cPort Credit Union

#	DATE	DESCRIPTION
A	09.14.17	PERMIT SET

ROOF PLAN

A201

A11 ROOF PATIO DECK PLAN

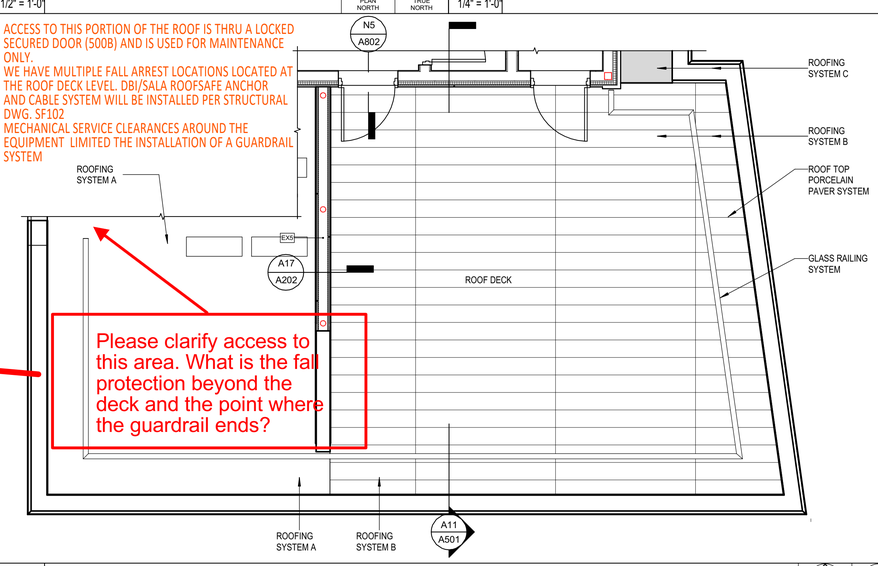
Please clarify access to this area. What is the fall protection beyond the deck and the point where the guardrail ends?

ACCESS TO THIS PORTION OF THE ROOF IS THRU A LOCKED SECURED DOOR (500B) AND IS USED FOR MAINTENANCE ONLY.
WE HAVE MULTIPLE FALL ARREST LOCATIONS LOCATED AT THE ROOF DECK LEVEL. DBI/SALA ROOFSAFE ANCHOR AND CABLE SYSTEM WILL BE INSTALLED PER STRUCTURAL DWG. SF102
MECHANICAL SERVICE CLEARANCES AROUND THE EQUIPMENT LIMITED THE INSTALLATION OF A GUARDRAIL SYSTEM
